# ASSESSMENT REPORT

## Cadia East Gold/Copper Project Modification of Project Approval (06\_0295 Mod 2)

Figure 3 – Proposed Modifications to BDF

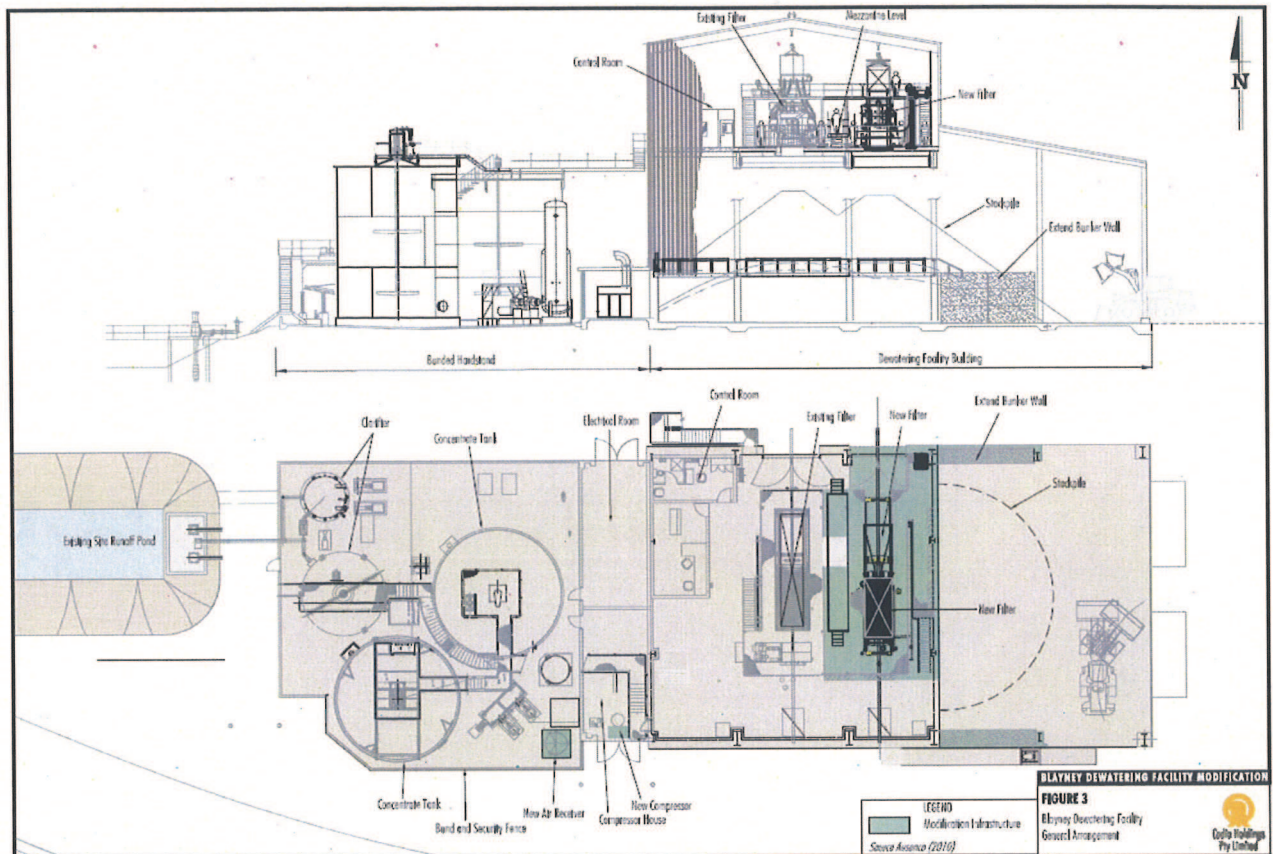
The increased capacity would require additional processing equipment including a filter press, sump pump, air receiver and compressor, to be installed within the approved BDF footprint (see Figure 3).

The modification has the potential to increase noise at receivers near the site, as a result of the installation of an additional filter press, sump pump, air receiver and compressor within the existing BDF footprint, as well as the increased quantity of concentrate to be dewatered, stockpiled and transported. However, the noise assessment found that noise impacts during adverse weather conditions could be reduced from current levels by up to 5 dB(A) with the implementation of proposed noise mitigation measures (see Table 2). These measures include the installation of a cover on the concentrate tanks, the replacement of the existing forklift with a quieter model and the enclosing of the container loading area to the north and south with cladding. The Department has recommended the noise impact assessment criteria for the BDF in the Cadia East project approval be amended to reflect the predicted noise levels identified in the noise assessment.

<i>Visual Amenity</i>	<p>The modification would result in the installation of additional dewatering components, although these would be installed wholly within the footprint of the existing building and hardstand area.</p> <p>The BDF is also located within an industrial landscape setting, immediately</p>	No change.
